Department of Energy  
Washington, D.C. 20545

Docket No. 50-537  
HQ:S:82:086

RESPONSES TO REQUEST FOR ADDITIONAL INFORMATION

Enclosed are responses to Questions CS 421.26, 43, 51, and 53 and CS 760.162,  
164, and 176 which will also be incorporated into a future PSAR Amendment.

Figure QCS760.176-1 Motor Tube, Hold-Down Ring, P. D. Housing, and Pressure Switch

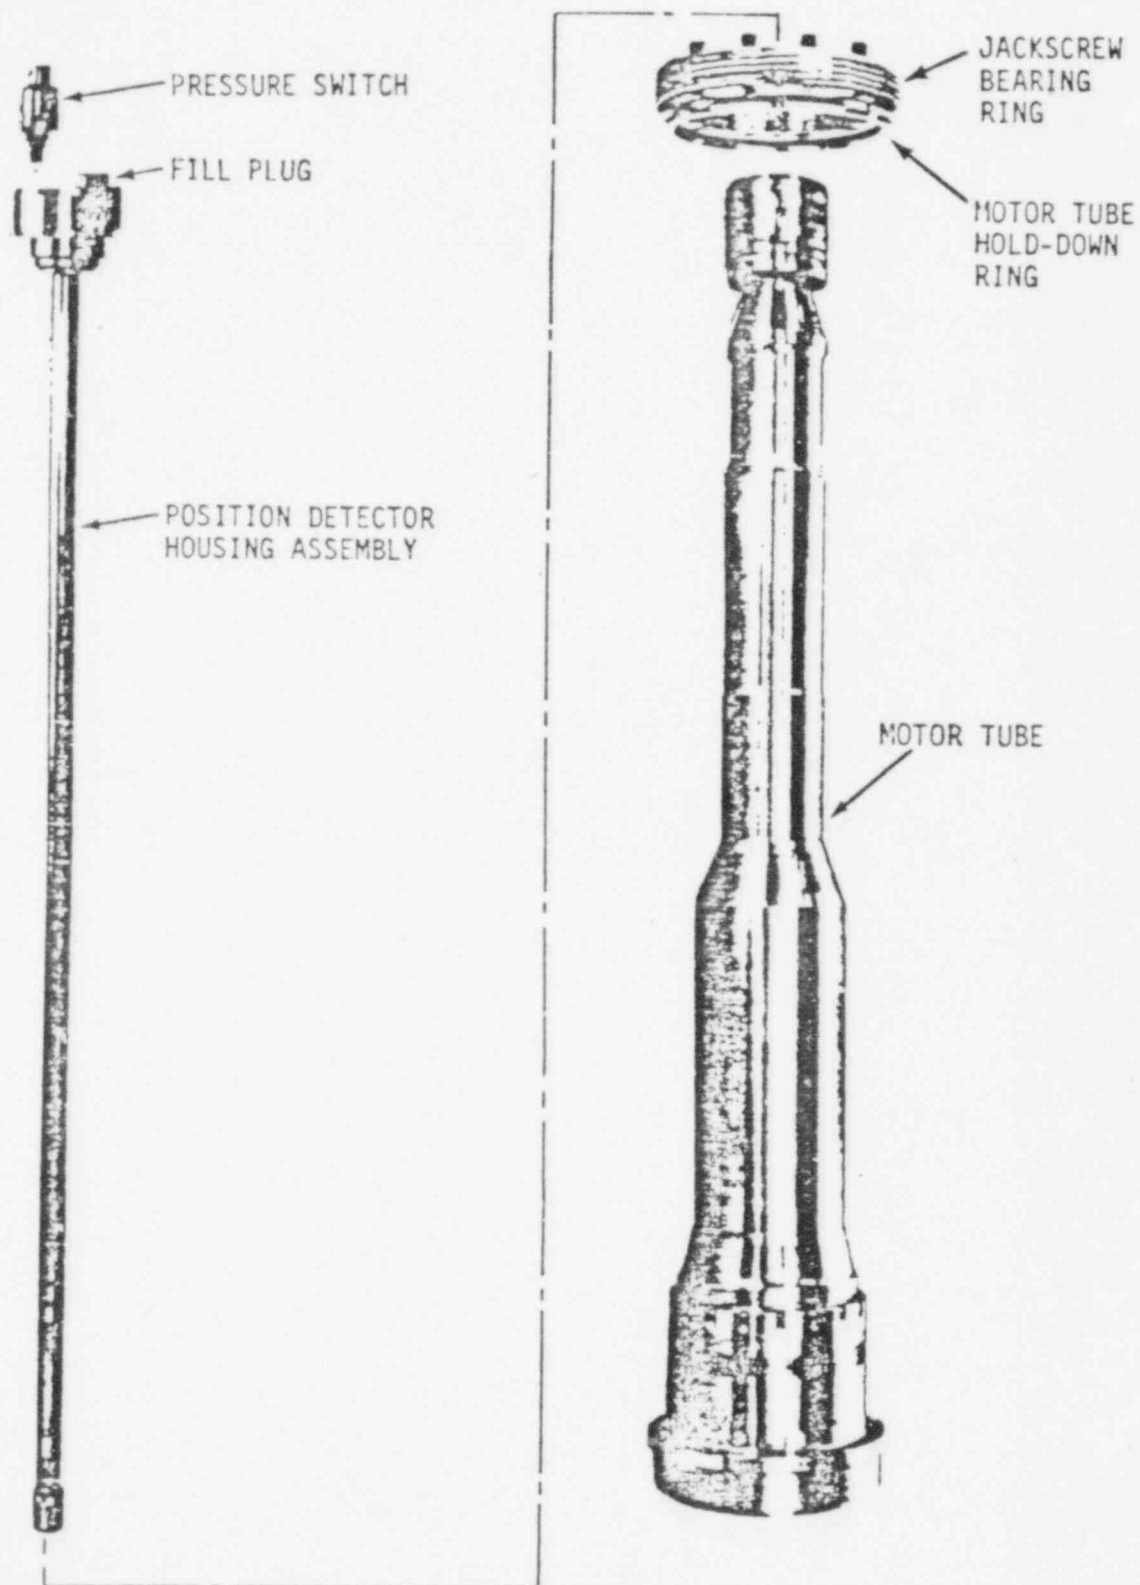
In preparation for writing those sections of the SER dealing with PCRD, we have found it necessary to secure additional documentation on the D. C. stepper motor used in the system. Specifically, we would like to obtain the following information:

1. Complete description of the motor
2. Equipment specification for the motor, and
3. Test information or data establishing that the specifications are met, including the maximum withdrawal speed in the event an over-speed signal is sent to the controller.

The PCRD utilizes a collapsible roller nut design which has been successfully used in the past on pressurized water reactors. This type of drive has a non-rotating leadscrew which is driven up or down by a fixed elevation roller nut formed by four ball bearing mounted rollers, equally spaced around the leadscrew. The rollers are inclined from vertical at the leadscrew helix angle and have teeth which engage the leadscrew threads to provide a positive connection to the translating assembly. Two rollers are mounted in each segment arm which are attached by pivot pins to a rotor carried on ball bearings in the motor tube. The complete assembly is shown in PSAR Figure 4.2-101. The motor tube is shown in Figure QCS760.176-1, the segment arms and roller nuts in Figure QCS760.176-2, and the stator in Figure QCS760.176-3.
